Division of Reclamation,
Mining and Safety

MEMO TO FILE

Subject/Operator/Operation/File No. High Grade Mill liner system is NOT considered an environmental protection facility (EPF) / Cresson Project / M-1980-244

Figure 4 from TR-81 submittal (note ~7 ft berm height)

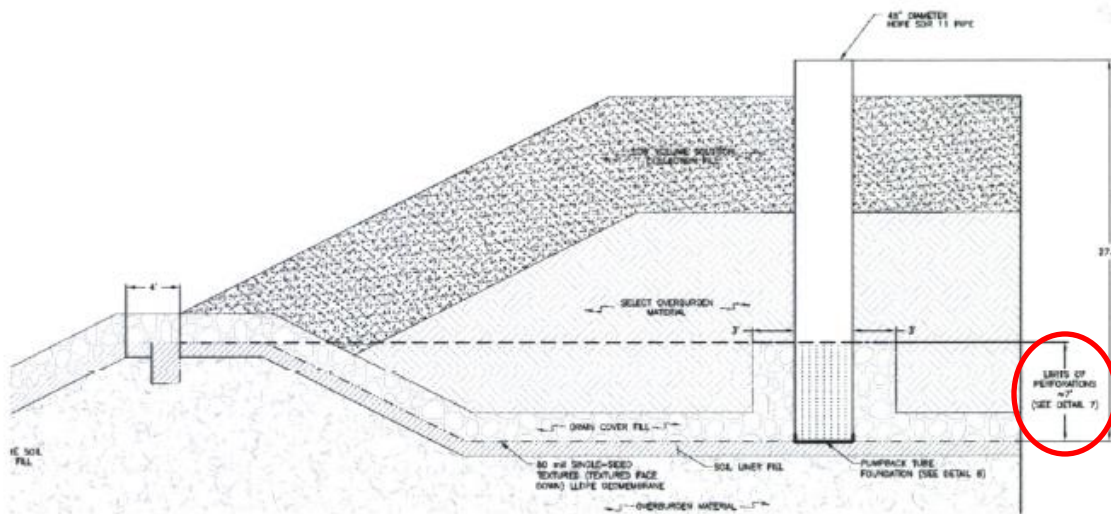
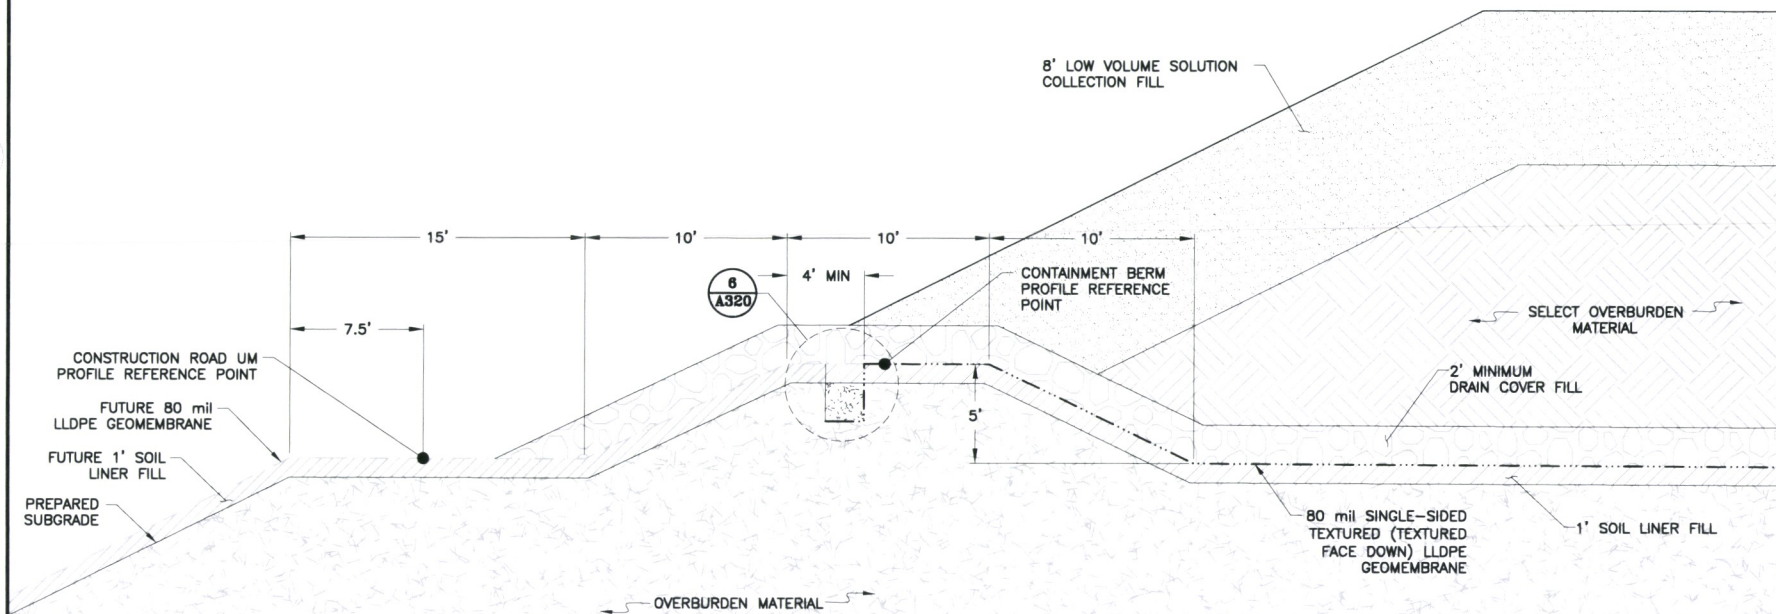
Subsequent to the review and approval of the mill platform in Amendment 10, the Division learned the HGM liner has some significant storage capacity as a subsurface lined berm on the southwest

corner of the mill platform (reference attached Drawing A320, Rev. 3, dated 8/16/12 in Vol. 1, Mill Site Earthworks Project, Final Report, Quality Assurance Monitoring and Test Results, dated January 31, 2014). The depth of storage is as much as 7 feet, based on Figure 4 provided in TR-81, received August 8, 2016 – see below. At this point in time there is no way to gravity drain the water infiltrating the mill platform and captured by the liner. The DRMS has concerns related to permanent water storage under the mill after reclamation and its influence on stability after pumping ceases. The DRMS has informally told CC&V/Newmont that a revised reclamation plan for the HGM liner is required to allow free drainage of water infiltrating the mill platform.
